**Correspondence Between
Staff and Applicant
Approval Letter**

Re:
7-ZN-2017, 1-II-2017 & 3-AB-2017
Winfield Hotel & Residences

RE: Request to Purchase Air Rights and Subterranean Easement, 3-AB-2017, 7-ZN-2017, and 1-II-2017,
Winfield Hotel & Residences

The Planning & Development Services Division has completed the review of the above referenced development application submitted on April 28, 2017. The following **1st Review Comments** represent the review performed by our team, and is intended to provide you with guidance for compliance with city codes, policies, and guidelines related to this application.

EXHIBIT "B"
~~18~~ 18' ALLEY ABANDONMENT

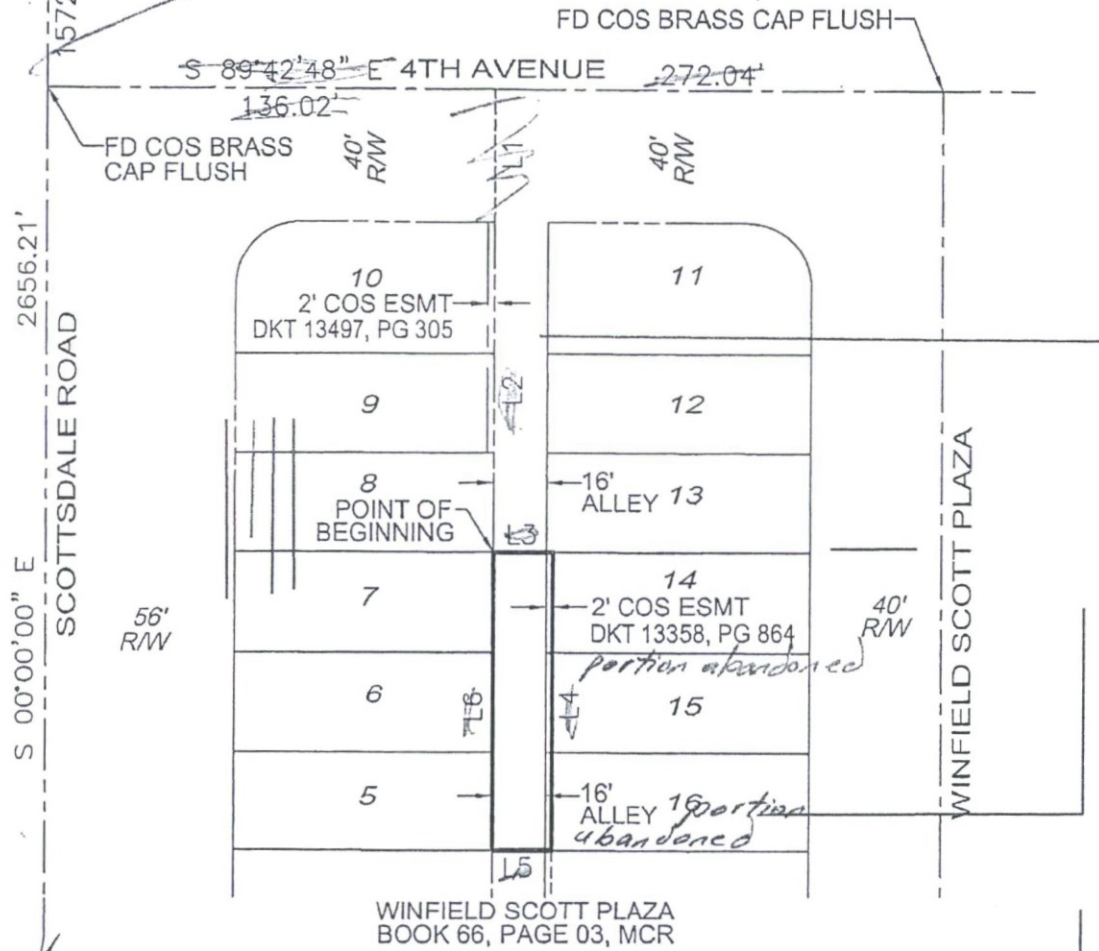
- E. Please submit a revised legal description of the abandonment area that addresses the markup comments included as Attachment A.
- F. As part of the City's abandonment of the alley right-of-way and right-of-way easement, the City will be reserving a public motorized access easement over the existing eighteen (18) foot wide abandonment area. Please provide a separate legal description and graphic of the eighteen (18) foot wide public motorized access easement reservation.

EXHIBIT "B"
~~AIR RIGHTS EASEMENT~~
 Defined Aerial Space

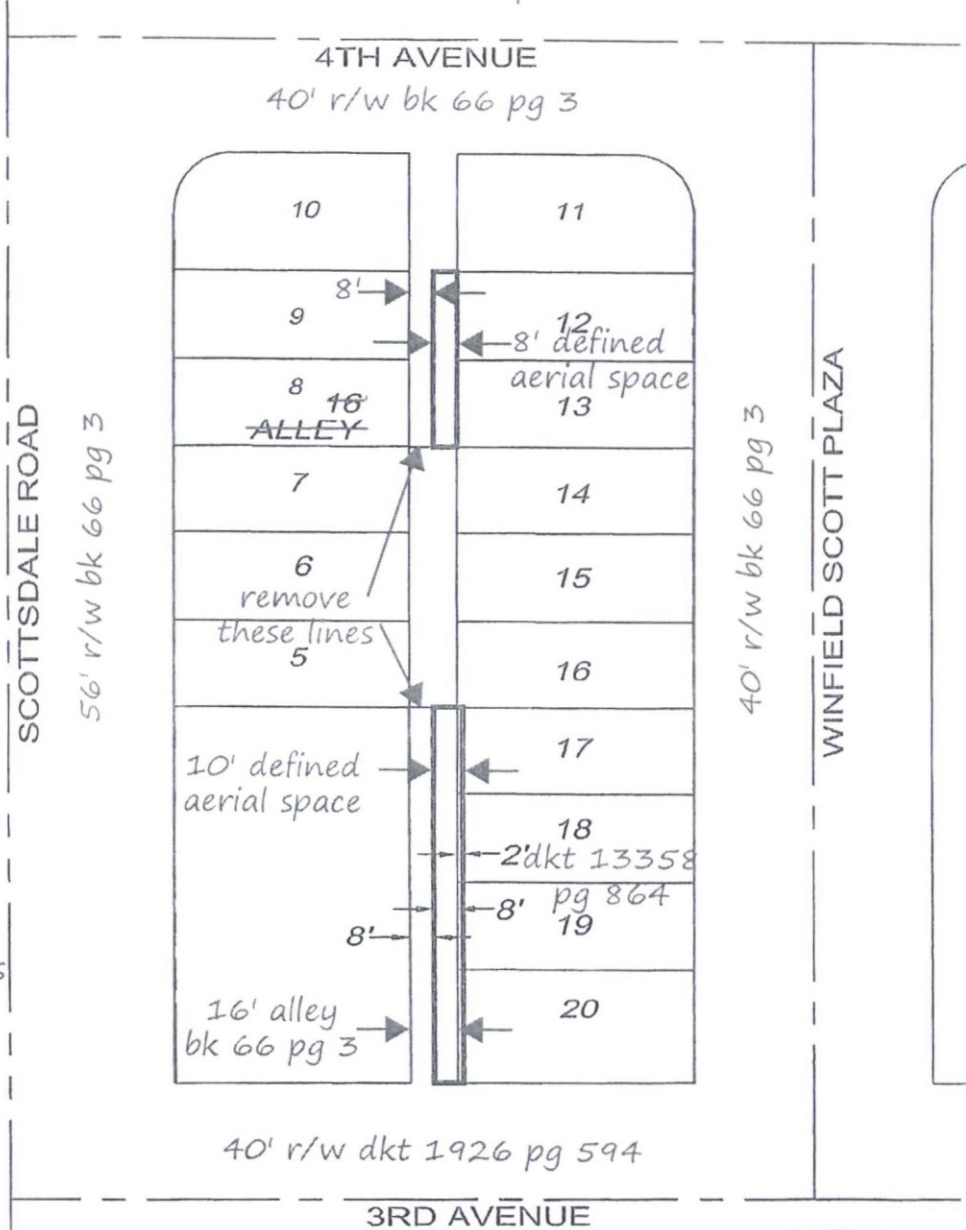
defined
 58' aerial
 space

use dashed line
 type to defined
 aerial space lines

the defined aerial space
 have a lower vertical
 plane of 16' above the
 finish floor and the upper
 vertical plane of 74'
 above the finish floor

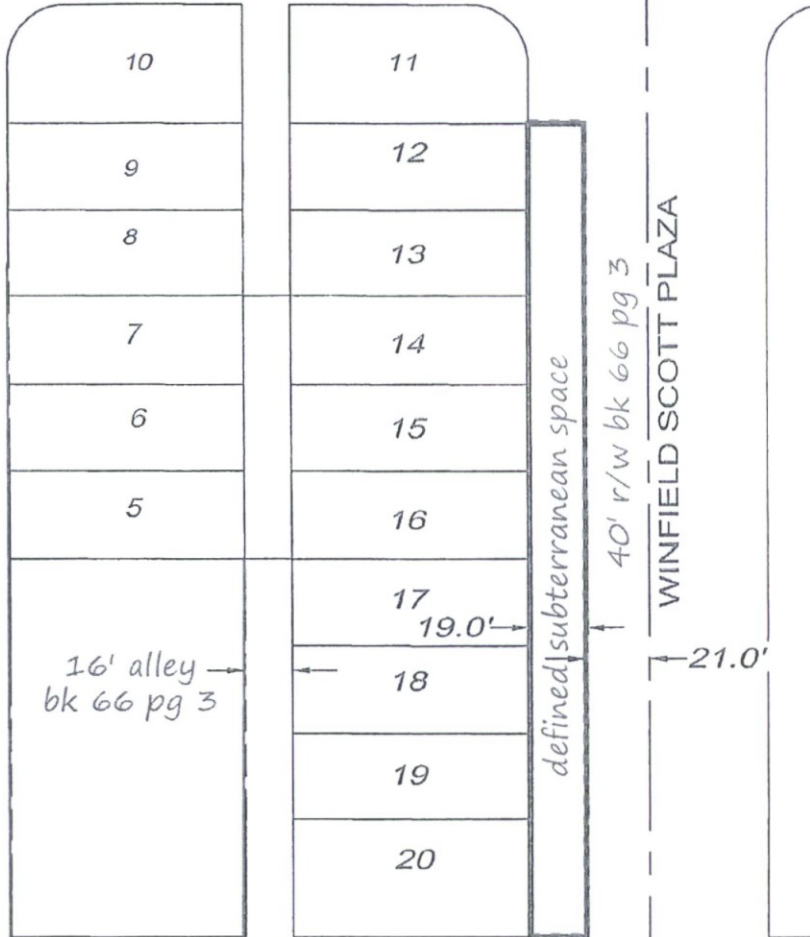
ff
 uvp
 1'
 defined
 47' subterranean
 space
 lvp
